RE: **PETITION NO. 1560** - The Connecticut Light and Power Company d/b/a Eversource Energy (Eversource) petition for a declaratory ruling, pursuant to Connecticut General Statutes §4-176 and §16-50k, for the proposed Norwalk Bridge Transmission Relocation Project that consists of the relocation and rebuild of two existing overhead 115-kilovolt (kV) electric transmission lines from railroad catenaries and existing structures within the Connecticut Department of Transportation corridor to an underground configuration within roads and across the Norwalk River for approximately .66 miles between existing Structure No. 522WN north of Monroe Street and Structure No. 536WN north of Van Zant Street in Norwalk, Connecticut, and related electric transmission line improvements.

#### Petition No. 1560 - Eversource Norwalk Bridge Transmission Relocation Project Norwalk, Connecticut

#### Interrogatories March 17, 2023

#### Area of Potential Effect Map

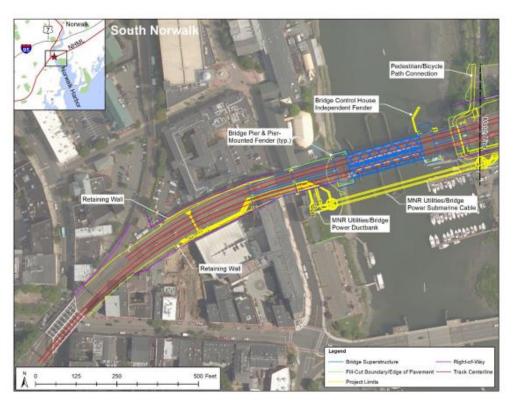
- a. Is the railroad listed on the NRHP?
  - b. Provide an aerial map that overlays the below CDOT Area of Potential Effect Map for the Norwalk Bridge Replacement project and depicts all above-ground NRHP-listed sites proximate to Eversource's transmission facility replacement project area. Provide the addresses or approximate street boundaries of each.

Figure 1 - Illustration of Project Limits, South Norwalk

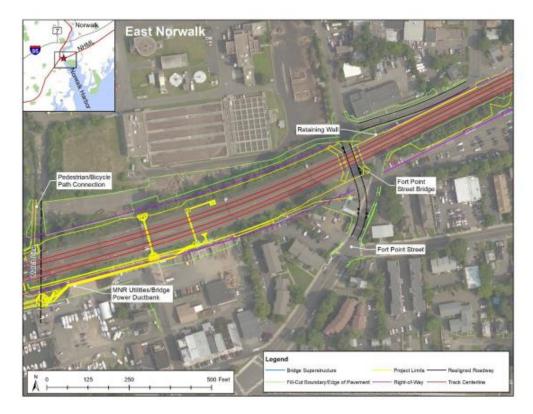
- a. Project limits (CDOT Figures 1 and 2);
  - b. Mitigation areas (CDOT Figure 3);
  - c. Parcel use locations (CDOT Figure 4);
  - d. Project activity locations (CDOT Figure 7).
